The applicant's plans, as contained within submitted document 2020-93954_+Proposed+Site++Block+Layout_957506.PDF seem odd.

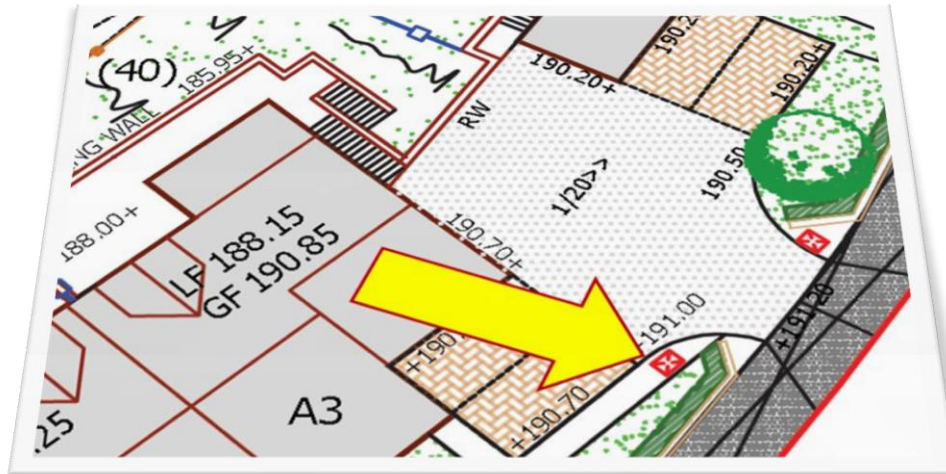
The applicant appears to be proposing a gate post that would be positioned away from the drive, on a footpath: *see yellow arrow below*.

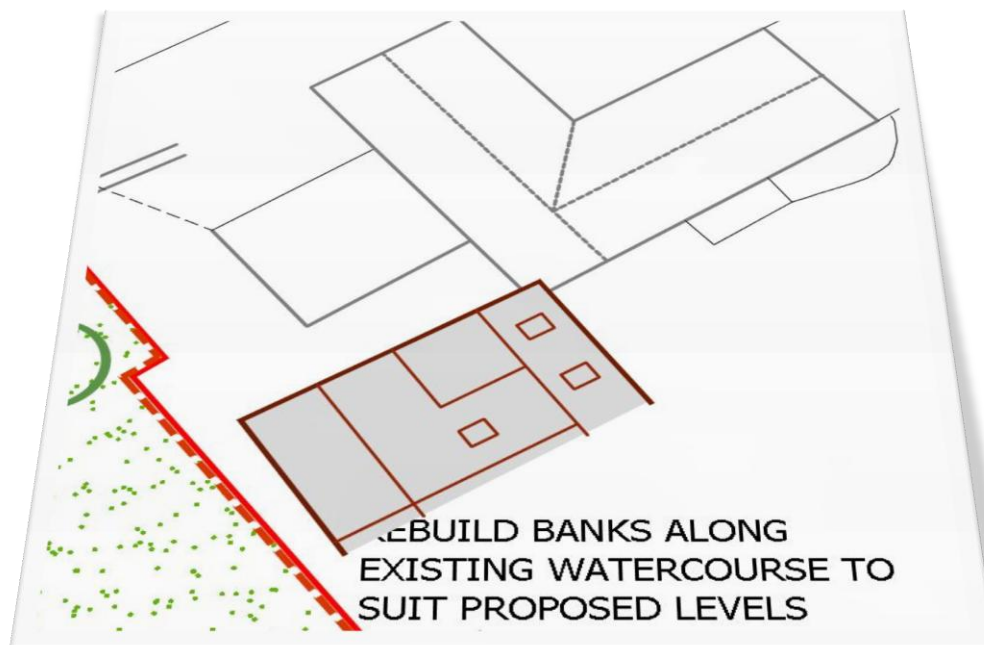
They also appear to be proposing to place a dwelling against Lower Wood Farm: *see image below*.

Neither of these can be classed as good design.
